PIC18F85J90 Family Silicon Errata and Data Sheet Clarification

The PIC18F85J90 family devices that you have received conform functionally to the current Device Data Sheet (DS39770C), except for the anomalies described in this document.

The following typographic corrections and clarifications are to be noted for the latest version of the device data sheet (DS39770C):

FIGURE 2-3 FREQUENCY vs. ESR PERFORMANCE FOR SUGGESTED VCAP

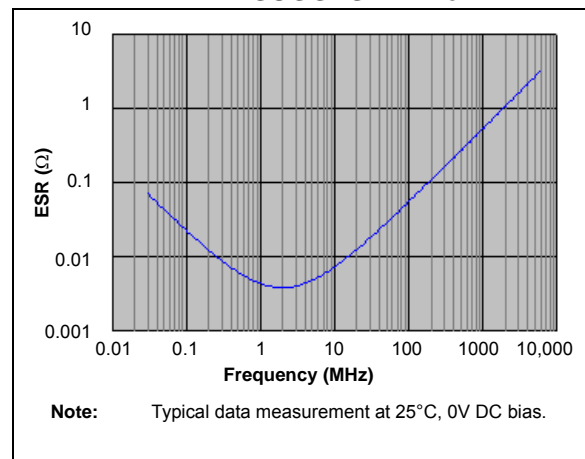
Section 2.4 “Voltage Regulator Pins (ENVREG and VCAP/VDDCORE)” has been replaced with a new and more detailed section. The entire text follows:

When the regulator is enabled, a low-ESR (< 5Ω) capacitor is required on the VCAP/VDDCORE pin to stabilize the voltage regulator output voltage. The VCAP/VDDCORE pin must not be connected to VDD and must use a capacitor of 10 μF connected to ground. The type can be ceramic or tantalum. Suitable examples of capacitors are shown in Table 2-1. Capacitors with equivalent specification can be used.

Designers may use Figure 2-3 to evaluate ESR equivalence of candidate devices.

It is recommended that the trace length not exceed 0.25 inch (6 mm). Refer to Section 26.0 “Electrical Characteristics” for additional information.

FIGURE 2-4 DC BIAS VOLTAGE vs. CAPACITANCE CHARACTERISTICS

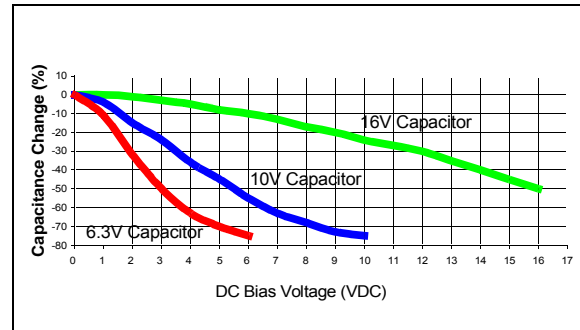
In addition to temperature tolerance, the effective capacitance of large value ceramic capacitors can vary substantially, based on the amount of DC voltage applied to the capacitor. This effect can be very significant, but is often overlooked or is not always documented.

A typical DC bias voltage vs. capacitance graph for X7R type and Y5V type capacitors is shown in Figure 2-4.

When selecting a ceramic capacitor to be used with the VDDCORE voltage regulator, it is suggested to select a high-voltage rating, so that the operating voltage is a small percentage of the maximum rated capacitor voltage. For example, choose a ceramic capacitor rated at 16V for the 2.5V VDDCORE voltage. Suggested capacitors are shown in Table 2-1.
